Planning, Zoning and Building Department

BOARD ACTION REPORT – APPEALABLE ITEM

Project Name:	777 North Ocean Boulevard
Project Location:	777 North Ocean Boulevard, Individually Listed as the Koch House
Request:	Certificate of Appropriateness, Variance and Waiver
Board:	Historic Preservation Board
Meeting Date:	August 1, 2018

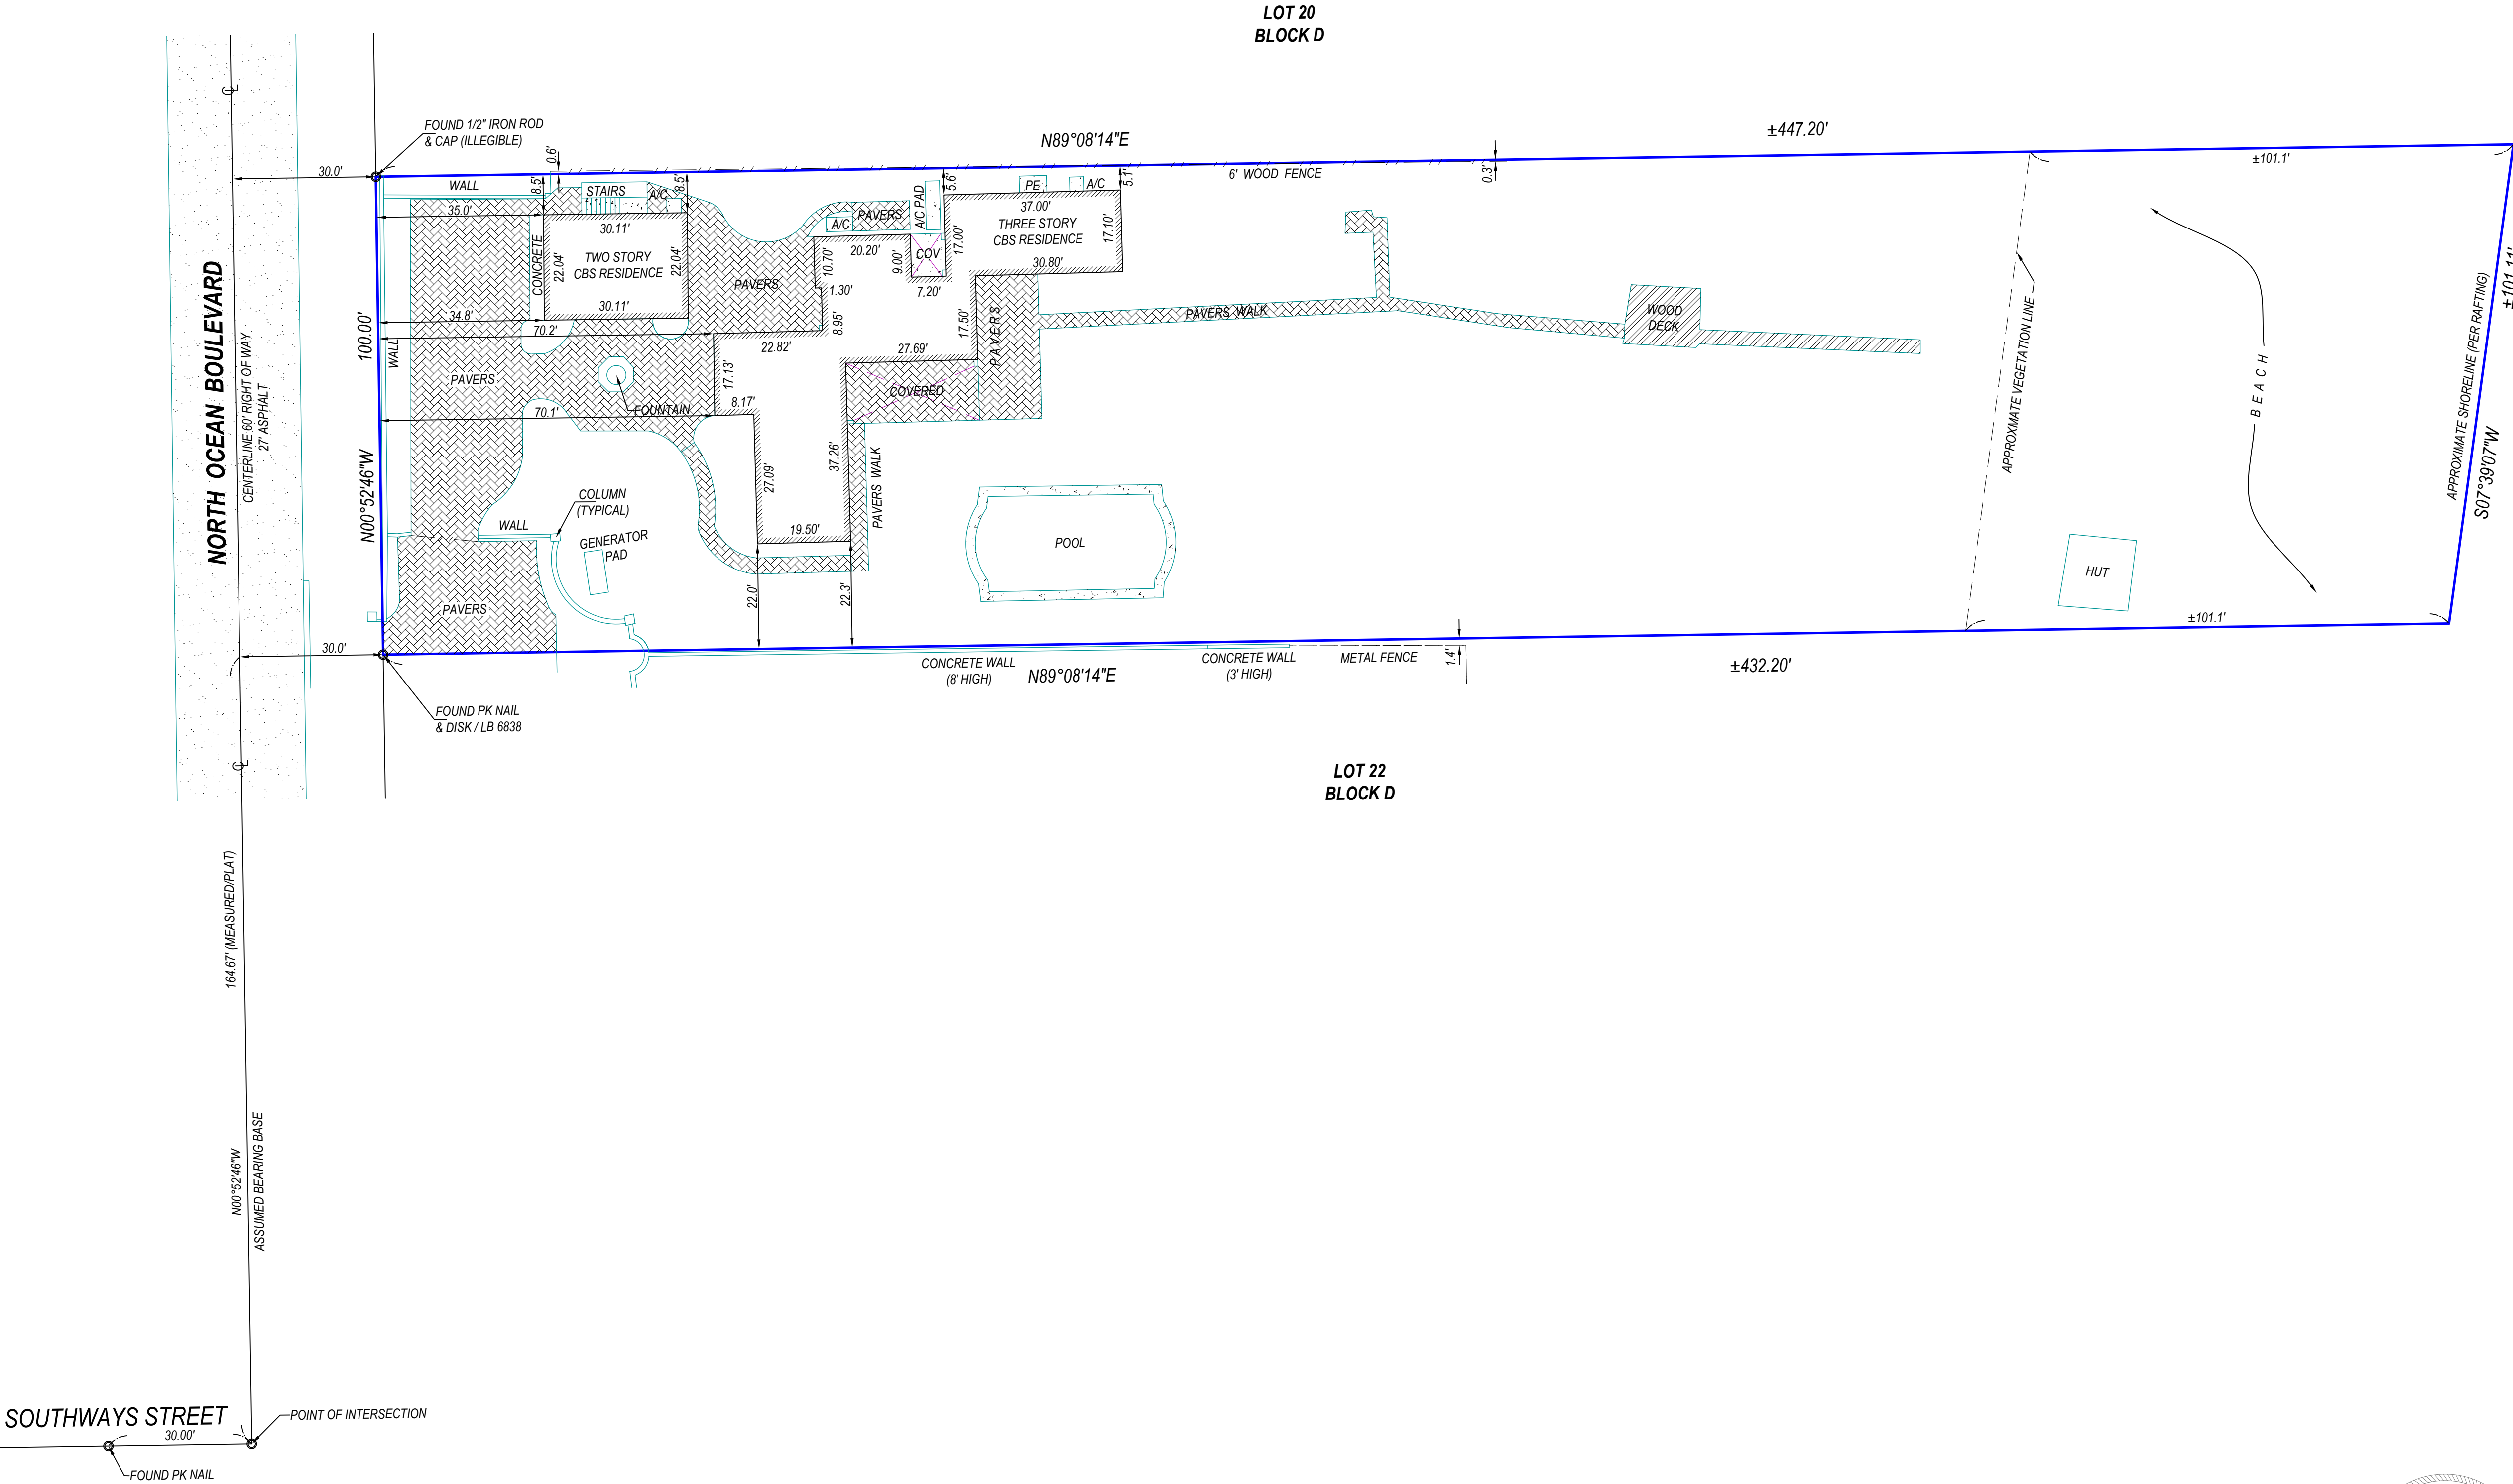
1. That the survey's legal description be revised to match the legal description on the property's warranty deed; and,
2. That the elevation drawings be revised to depict the staircase and cabana bathroom located on the north side of the garage/guest house on sheet A5.1.

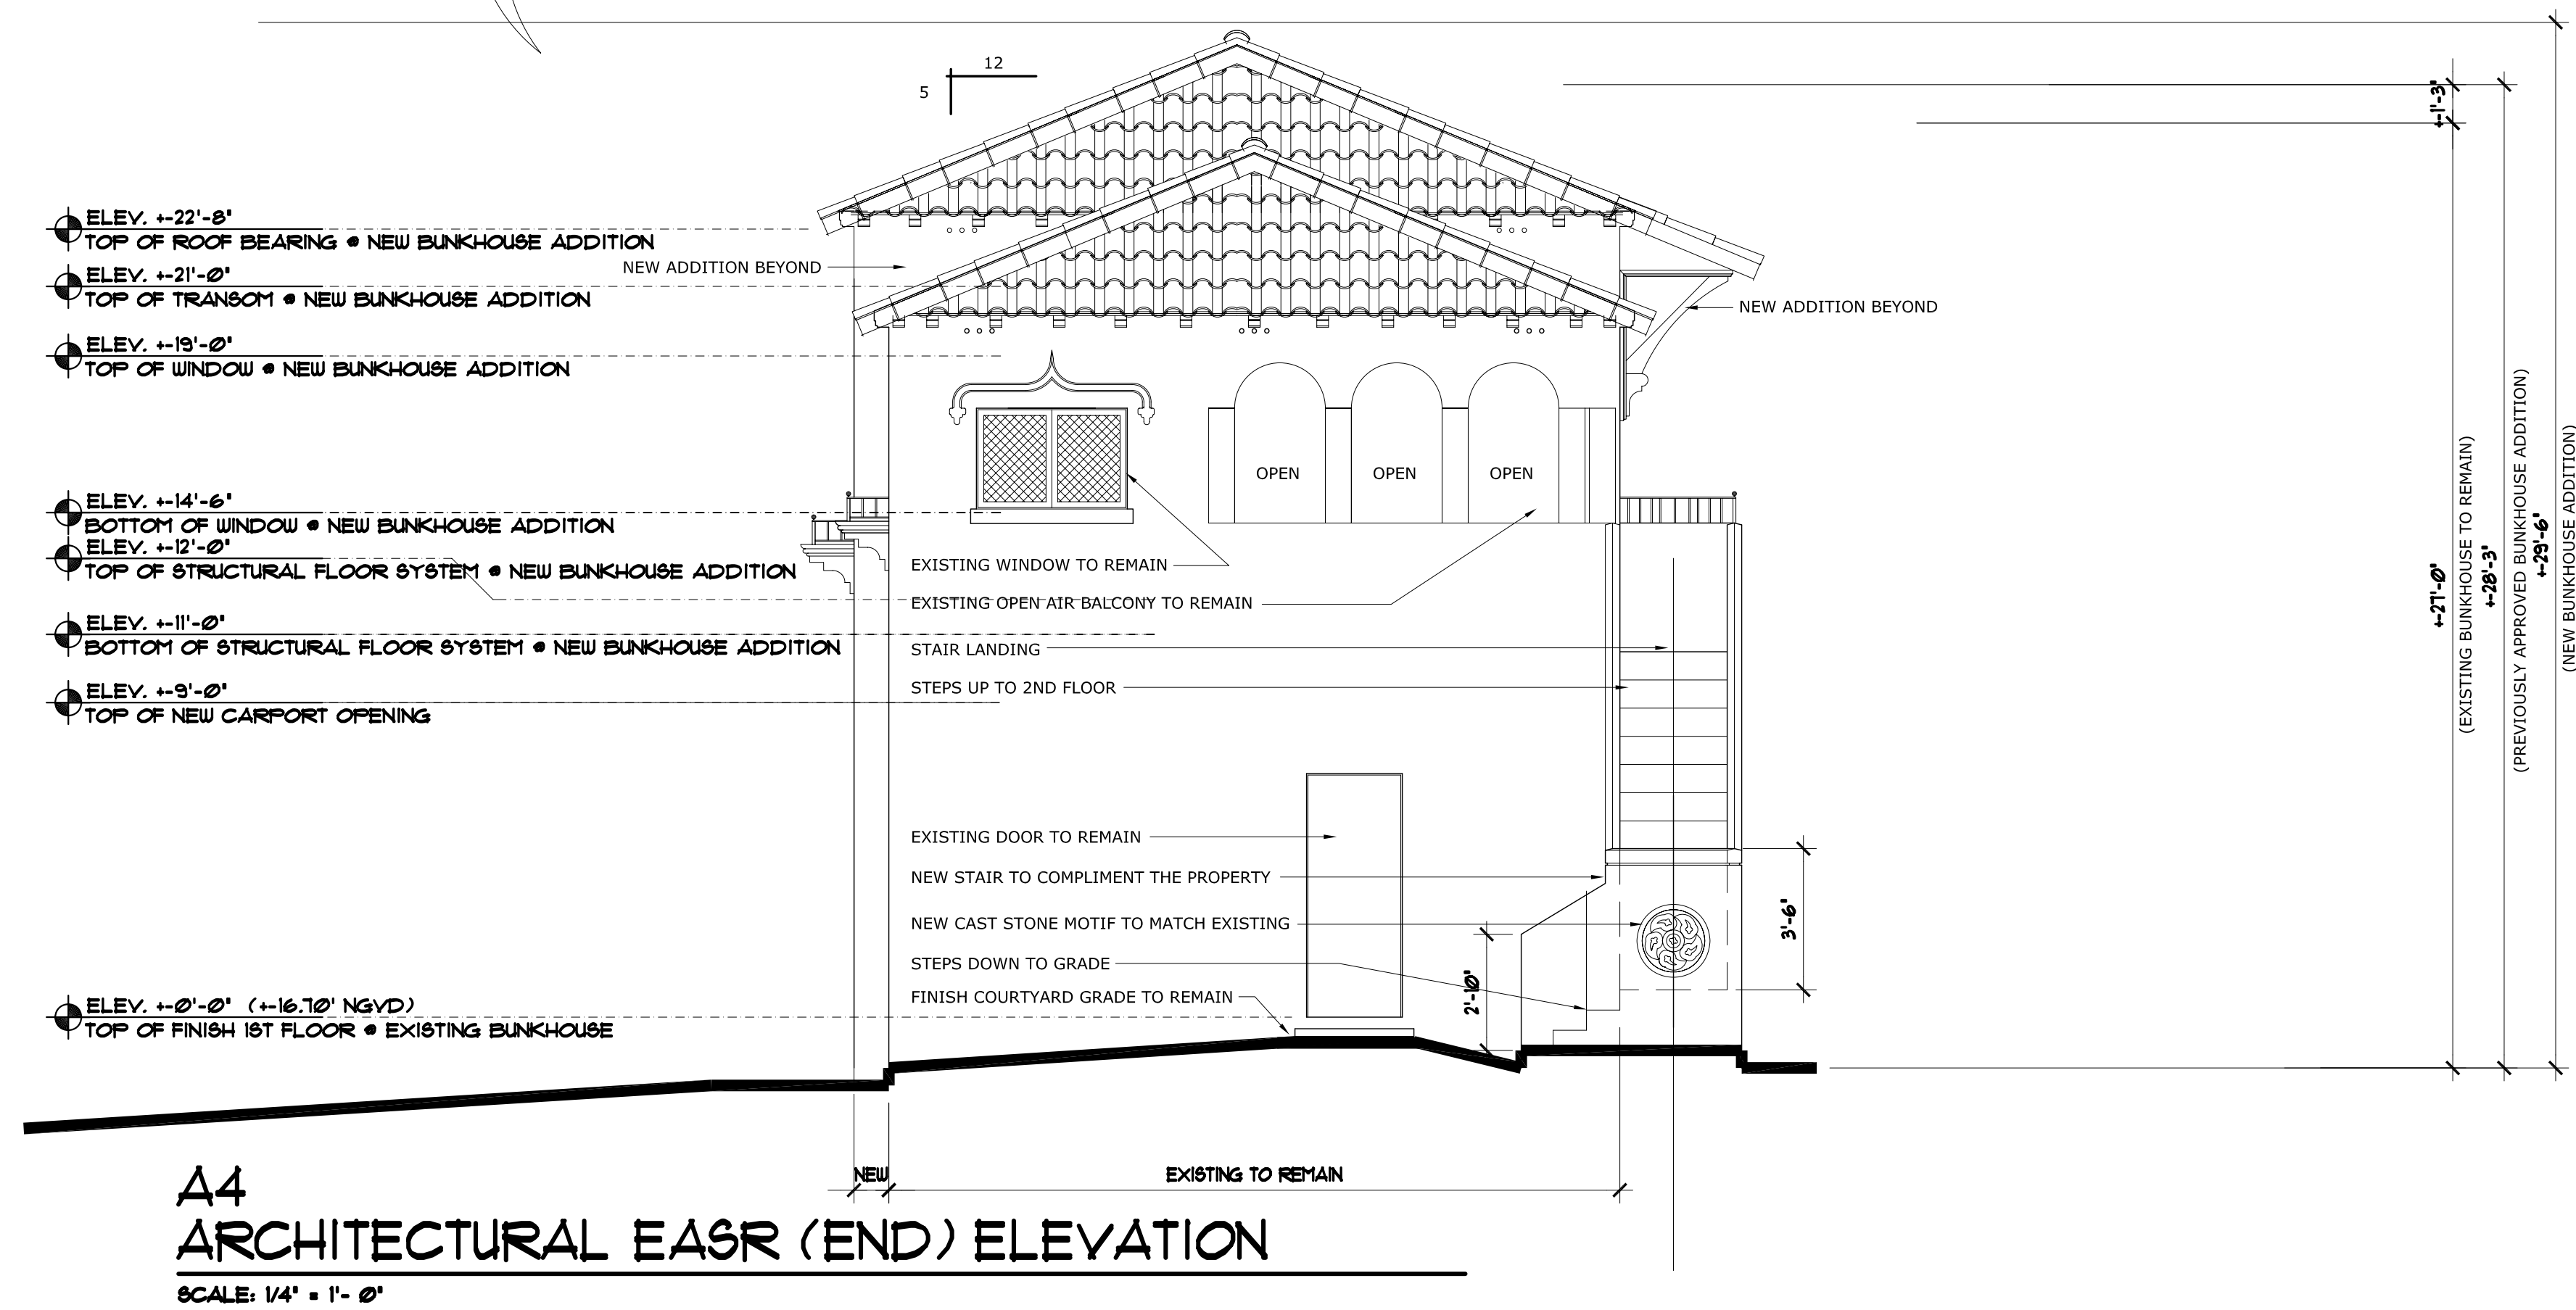
1. That the survey's legal description be revised to match the legal description on the property's warranty deed; and,
2. That the elevation drawings be revised to depict the staircase and cabana bathroom located on the north side of the garage /guest house on sheet A5.1.
